ADDENDUM NO. 3 TO PLANS AND CONTRACT DOCUMENTS
FOR
GRAND LIARD MARSH AND RIDGE RESTORATION
(BA-68)
PLAQUEMINES PARISH, LOUISIANA

STATE OF LOUISIANA
COASTAL PROTECTION AND RESTORATION
AUTHORITY

JANUARY 15, 2014

GRAND LIARD MARSH AND RIDGE RESTORATION	MARSH CREATION AREA LAYOUT
STATE PROJECT NUMBER: BA-68	DATE: OCTOBER 2013
FEDERAL PROJECT NUMBER: BA-68	SHEET 5 OF 54
APPROVED BY: RUDOLPH SIMONEAUX, P.E.

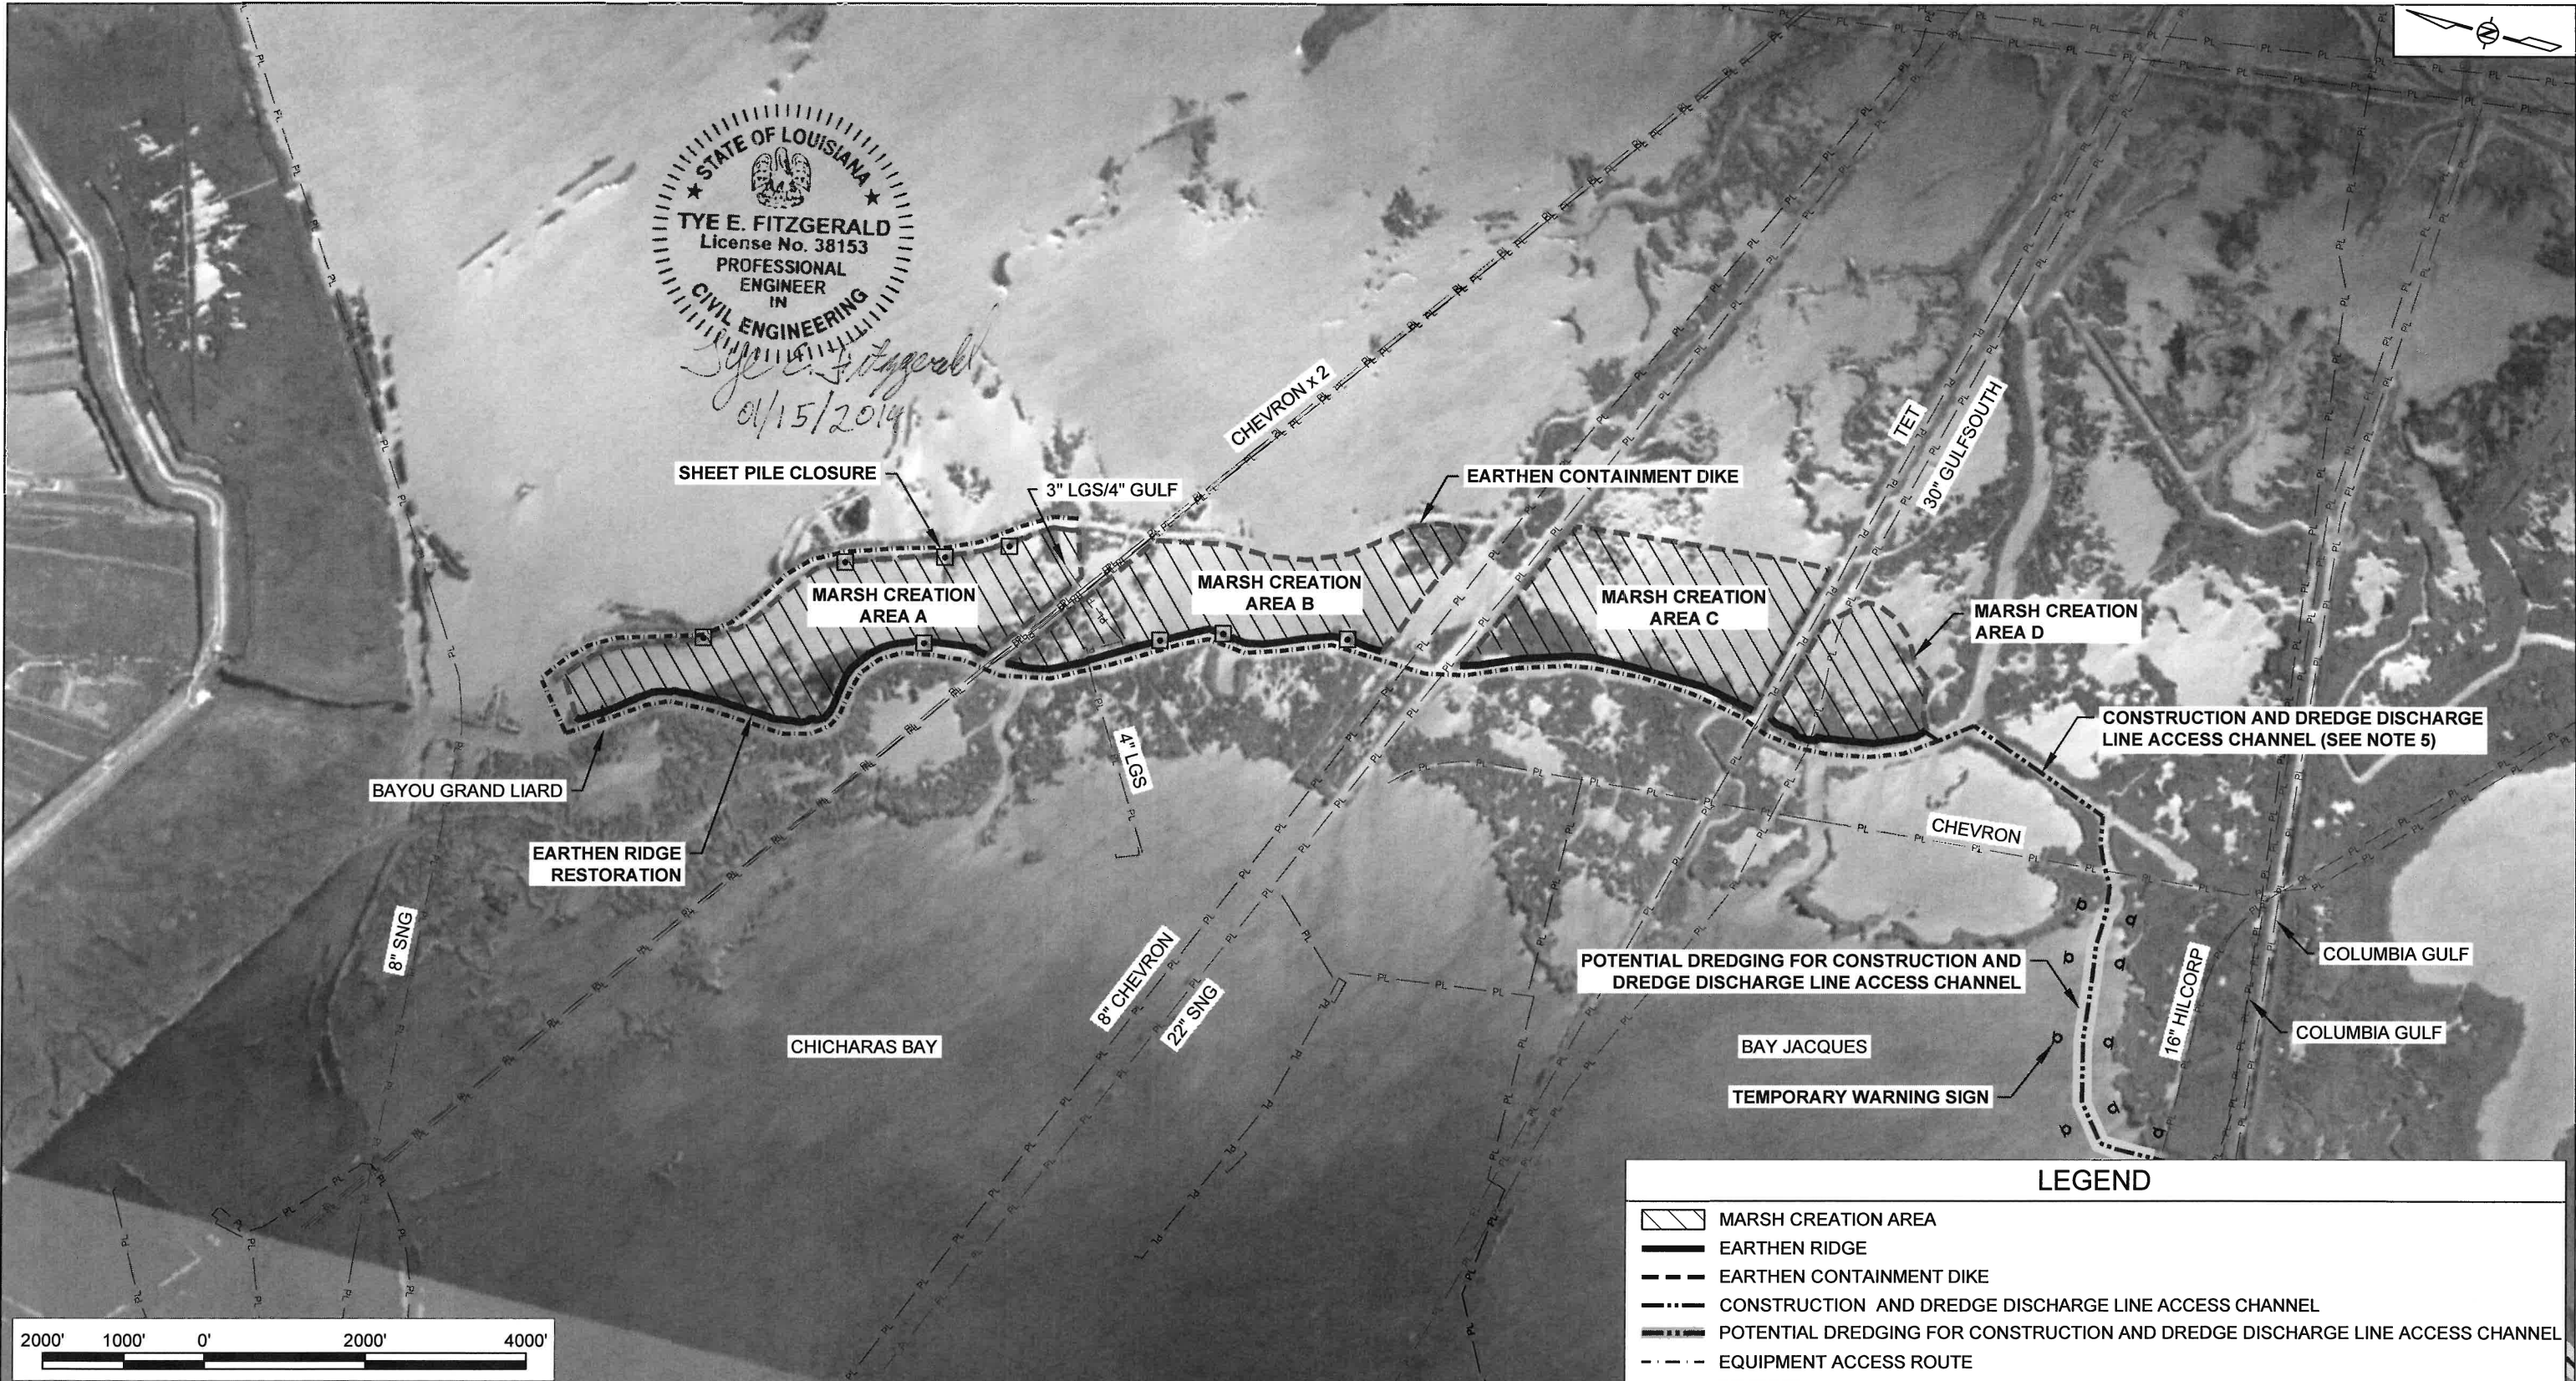
1. **Sheet 5 of 54:**

- a. Revised 2” GULF pipeline callout in Marsh Creation Areas A and B to:

“3” LGS/4” GULF”

- b. Removed erroneous 2” LGS callout in Marsh Creation Area B.

1	1/9/2014	REMOVED ERRONEOUS 2" LGS CALLOUT IN MARSH CREATION AREA B.	KC
2	1/9/2014	REVISED 2" GULF CALLOUT TO 3" LGS/4" GULF FOR PIPELINE IN MARSH CREATION AREAS A & B.	KC
REV.	DATE	DESCRIPTION	BY

SHEET 6 OF 54

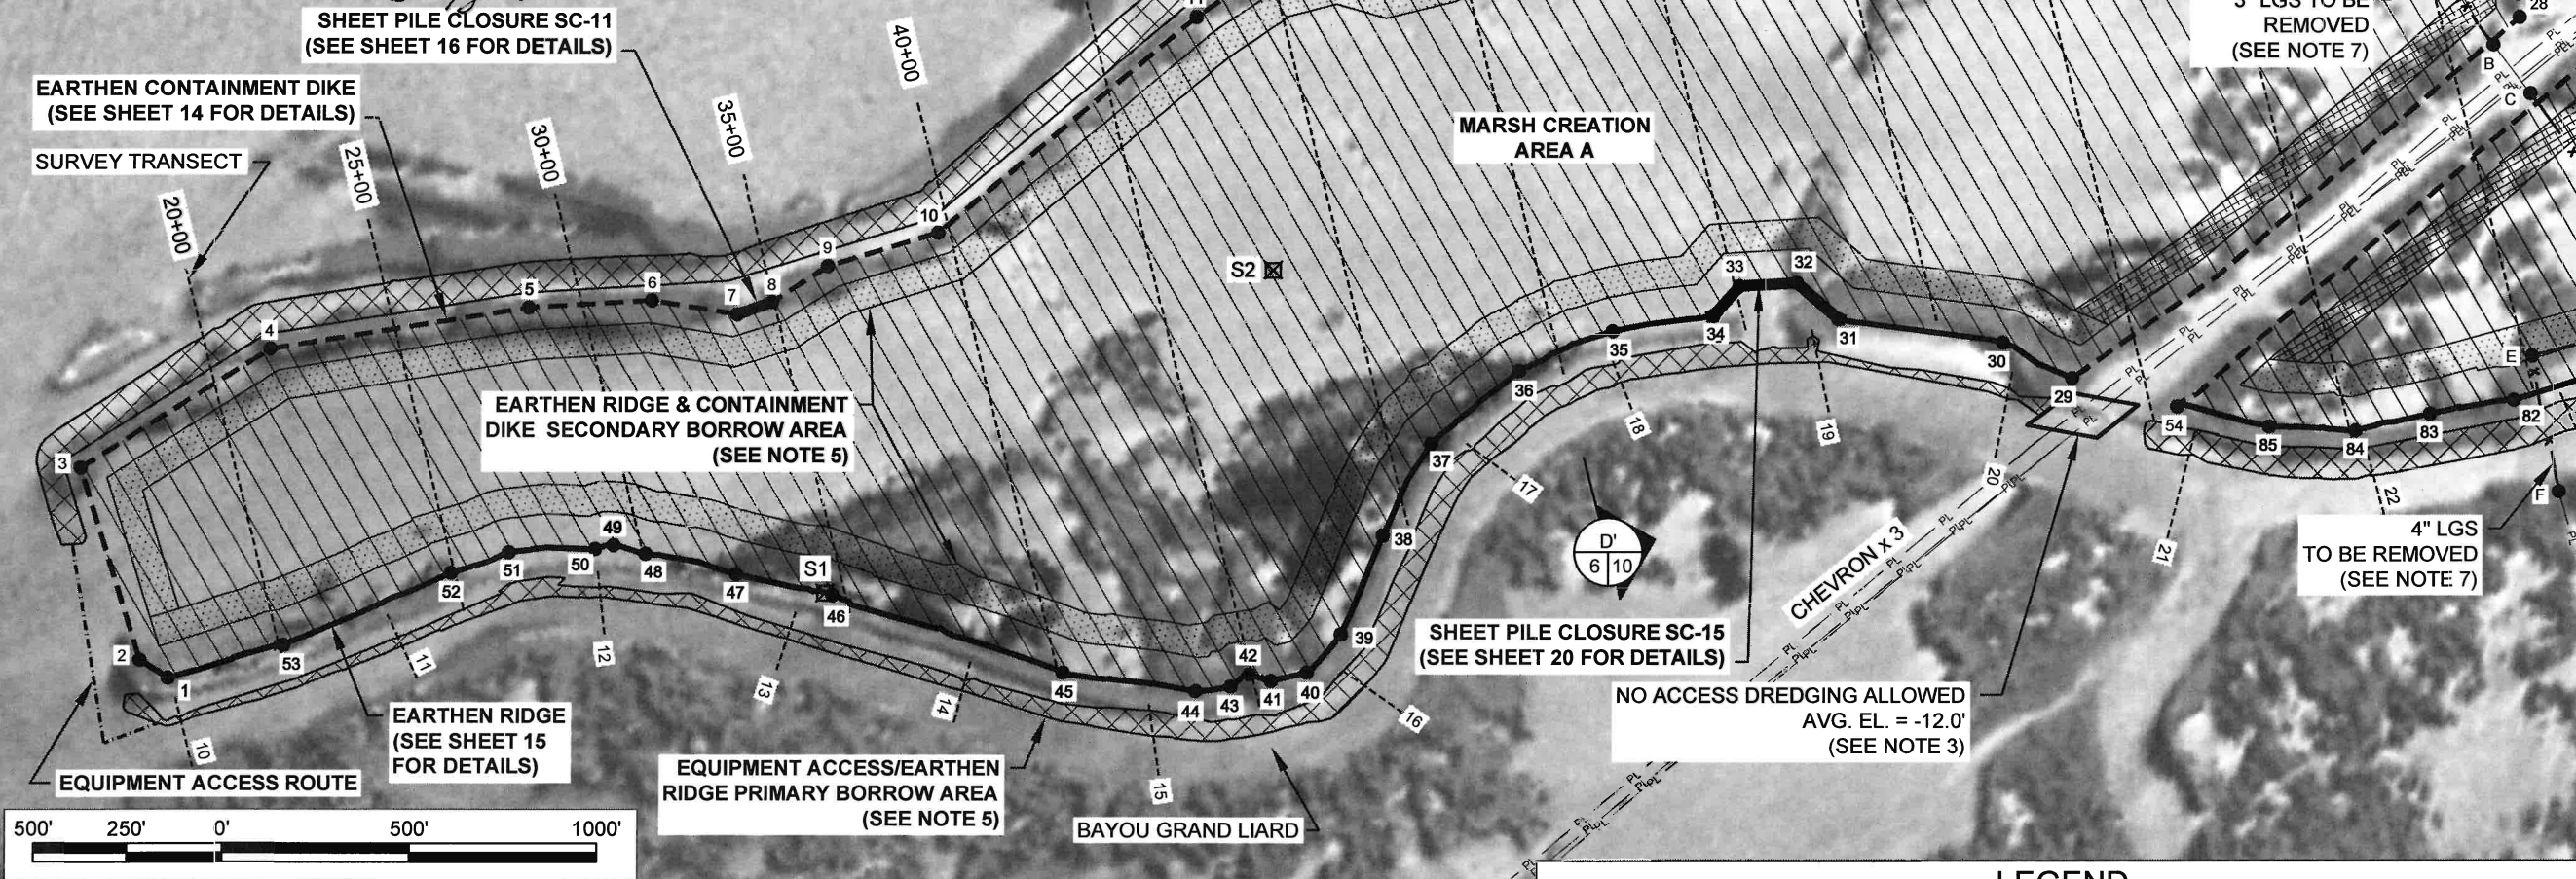
2. Sheet 6 of 54:

- a. Removed erroneous 2" LGS callout in Marsh Creation Area B.
- b. Revised 2" GULF pipeline callout in Marsh Creation Areas A to:

"3" LGS"

- c. Note 7 was revised to:

"THE 3" AND 4" LOUISIANA STATE GAS CORPORATION PIPELINES SHALL BE CUT AND REMOVED BY THE CONTRACTOR. SEE TS-3 OF THE SPECIFICATIONS AND SHEET 7 FOR MORE DETAILS."

1	1/9/2014	REMOVED ERRONEOUS 2" LGS CALLOUT IN MARSH CREATION AREA B.	KC
2	1/9/2014	REVISED PIPELINE REMOVAL CALLOUT SHOWN IN MC AREA A. 2" GULF WAS REVISED TO 3" LGS.	KC
3	1/9/2014	2" GULF SOUTH WAS REVISED TO 3" & 4" LOUISIANA STATE GAS CORPORATION IN NOTE 7.	KC
REV.	DATE	DESCRIPTION	BY

SHEET 7 OF 54

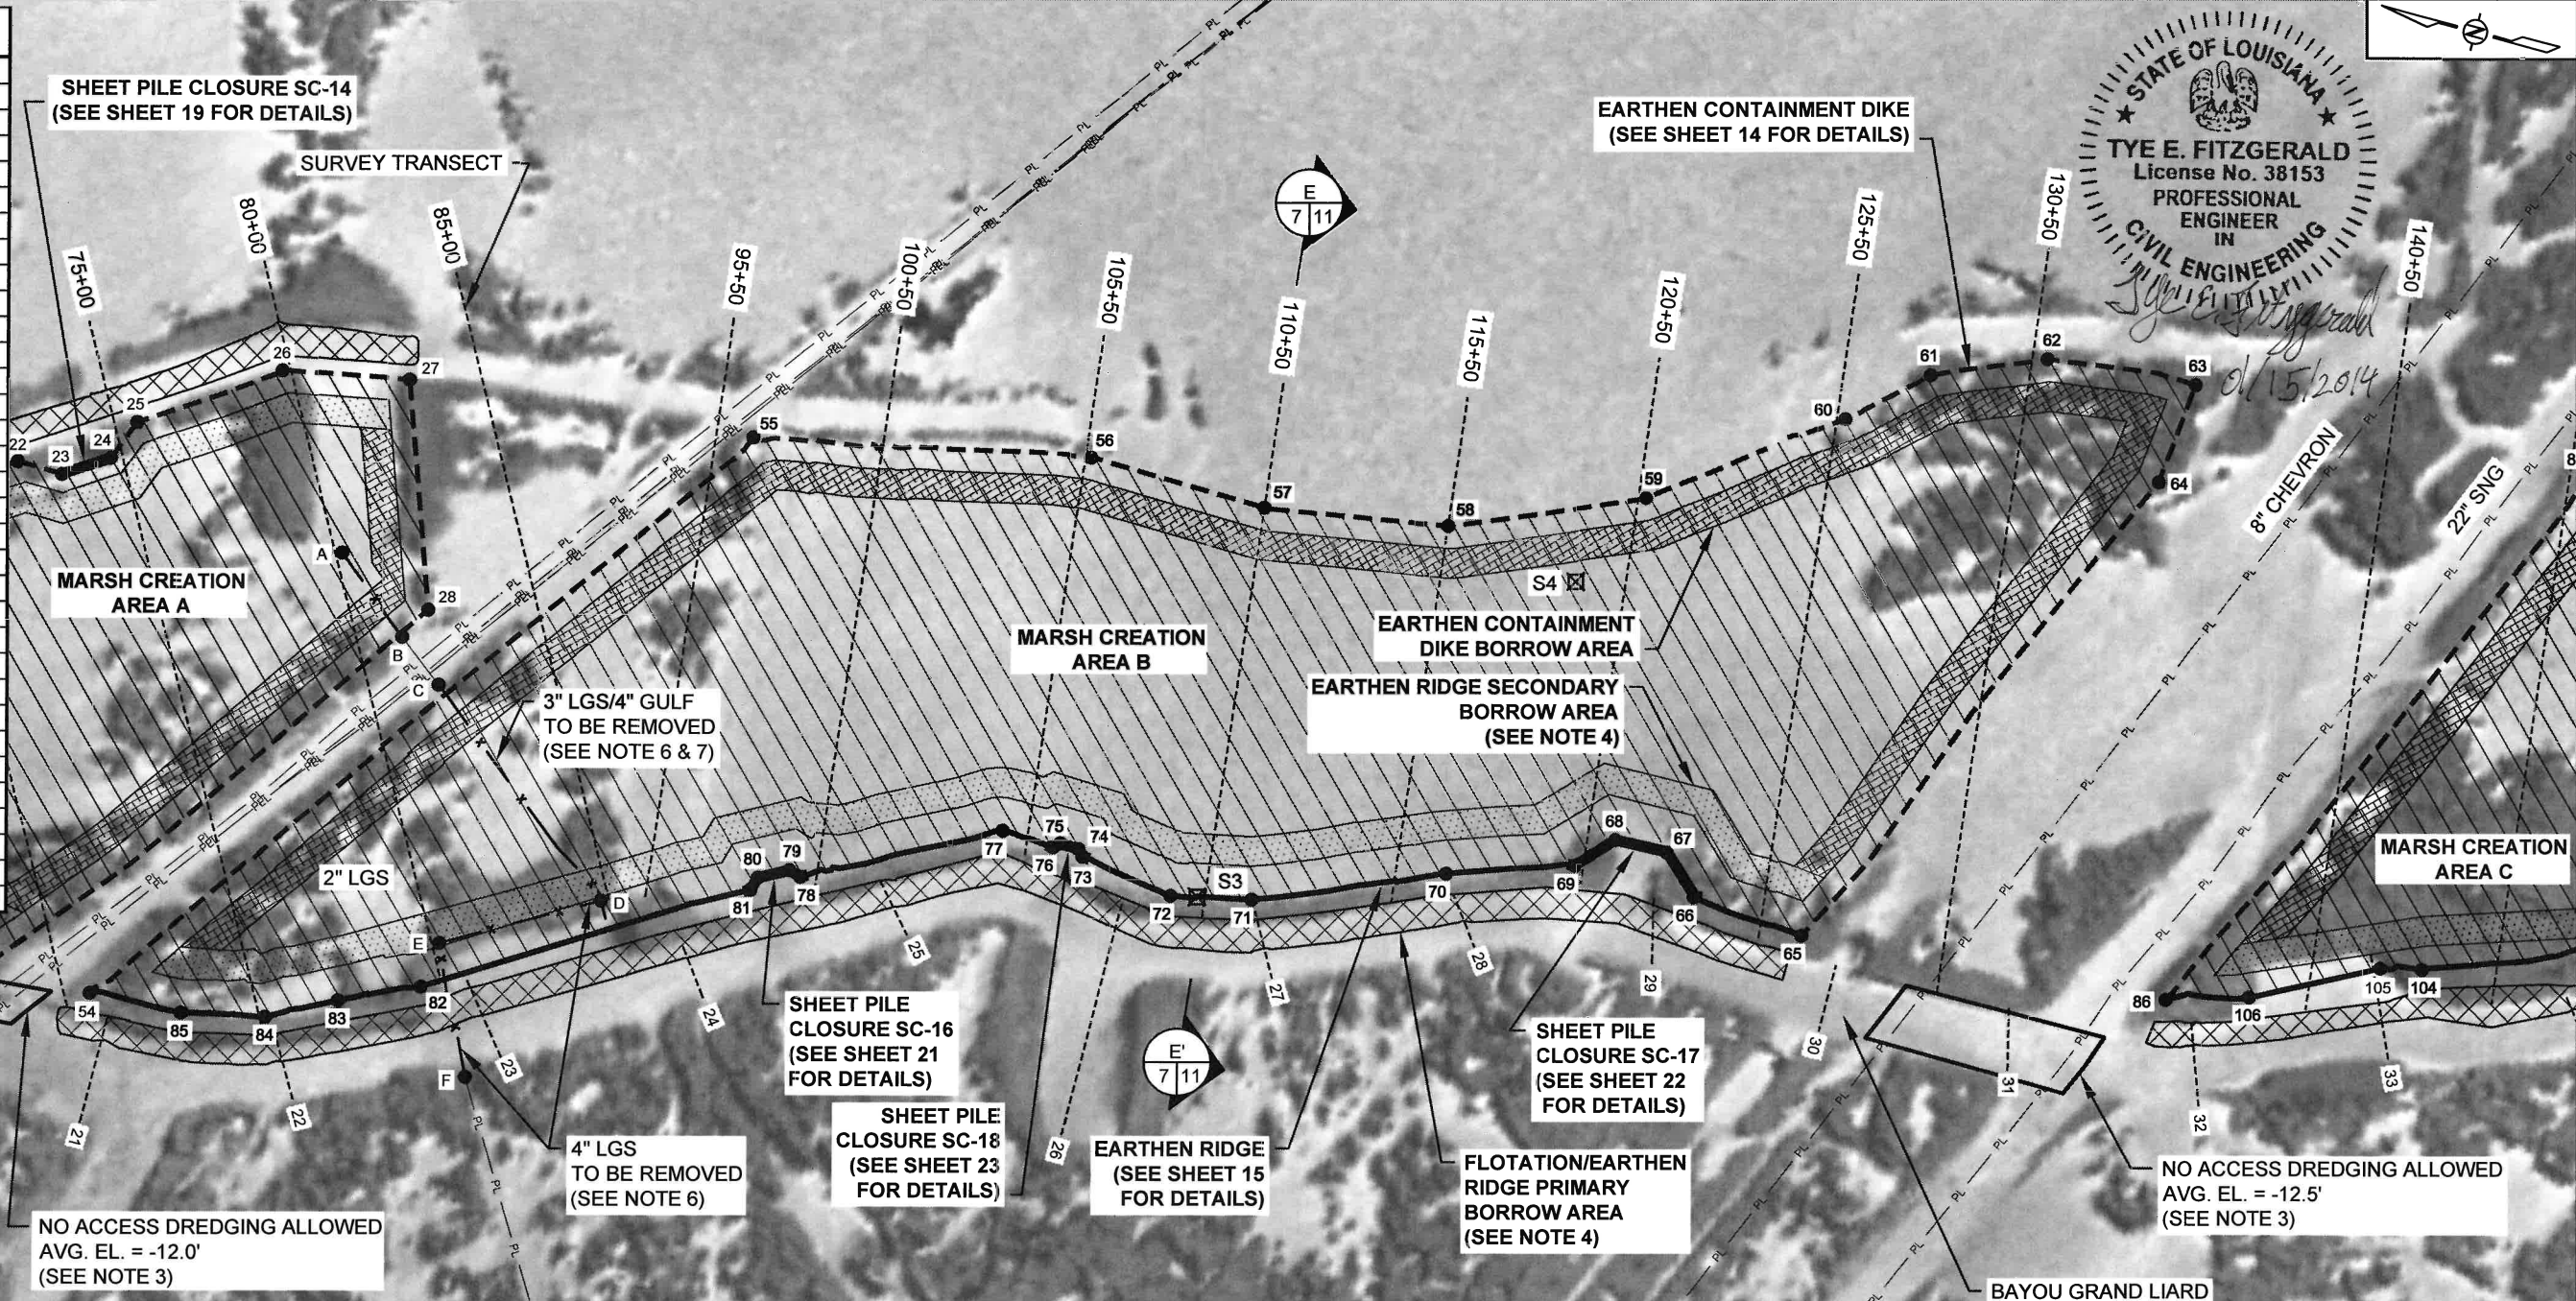
Contractor Question/Comment (25): Specification Section TS-3, Pipeline Removal, paragraphs 3.1 and 3.2, mention the removal of approximately 3,400 feet of pipeline; however, the distances between the points listed on plan sheet 7 and associated C.U.P.s total about 2,500 feet. Is the Contractor required to remove quantity listed in TS-3, 3.2, or only the portions between the points on plan sheet 7?

Contractor Question/Comment (26): Are the pipeline segments entering the Chevron pipeline corridor, between points B and C on plan sheet 7, to be removed or will they be capped and remain in-place, at point B and point C?

3. Sheet 7 of 54:

- a. Revised 2" GULF pipeline callout in Marsh Creation Areas B to:

"3" LGS/4" GULF TO BE REMOVED (SEE NOTES 6 AND 7)"

- b. Note 6 was revised to:

"THE 3" AND 4" LOUISIANA STATE GAS CORPORATION PIPELINES SHALL BE CUT AND REMOVED BY THE CONTRACTOR. SEE TS-3 OF THE SPECIFICATIONS FOR MORE DETAILS."

- c. Note 7 was add:

"THE 4" GULF SOUTH PIPELINE SHALL BE CUT AND REMOVED BETWEEN POINTS C AND D BY THE CONTRACTOR. SEE TS-3 OF THE SPECIFICATIONS FOR MORE DETAILS."

CPRA Response (25): There are two pipelines located between points C and D. The Contractor is only required to remove the pipelines between the points listed on Plan Sheet 7 (A-B and C-D-E-F). Pipeline sections between points B-C shall be flushed, capped, and remain in-place.

1	1/9/2014	REVISED PIPELINE REMOVAL CALLOUT SHOWN IN MC AREA B. 2" GULF WAS REVISED TO 3" LGS/4" GULF.	KC
2	1/9/2014	2" GULF SOUTH WAS REVISED TO 3" & 4" LOUISIANA STATE GAS CORPORATION IN NOTE 6.	KC
3	1/9/2014	NOTE 7 WAS ADDED.	KC
REV.	DATE	DESCRIPTION	BY
